<b>B 1</b>	SEQUENCE NO. (MDE USE ONLY) <b>59798</b>	STATE OF MARYLAND <b>APPLICATION FOR PERMIT TO DRILL WELL</b> <i>564786</i> please type	STATE PERMIT NUMBER <b>HO-18-0013</b> <small>70 fill in this form completely 79</small>
------------	--	---	---

**RE:** Replacement well permit for 13039 Clarksville Pike

**SITE INSPECTION SHEET**

**LOCATION DIAGRAM**

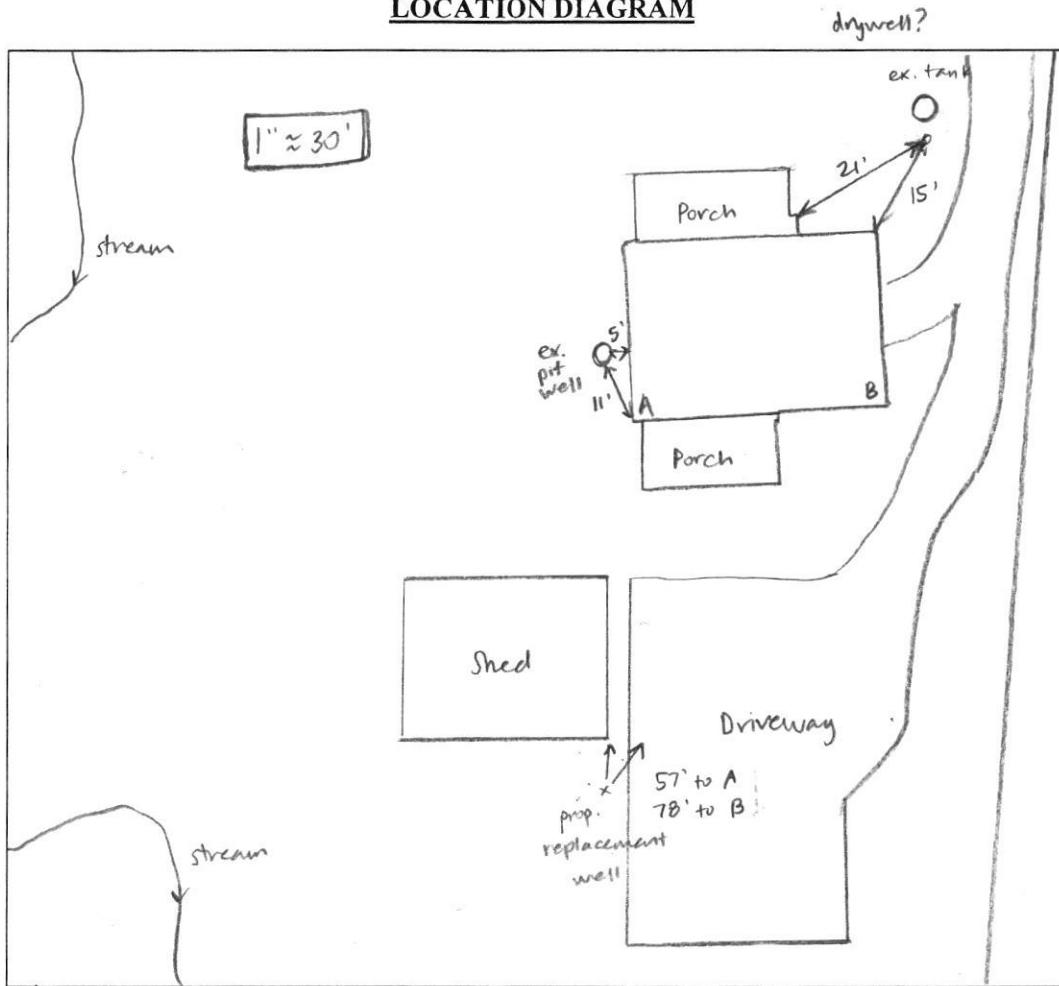
COMMENTS: Met Allen Compton and homeowner on site. Proposed  
drilling off the driveway near the shed. Location is ~120' from the  
septic tank, 60' from the stream. Homeowner says the septic tank  
connects to a drywell. Septic repair area likely in the front yard,  
the highest part of the property.

→ also rear corner of property
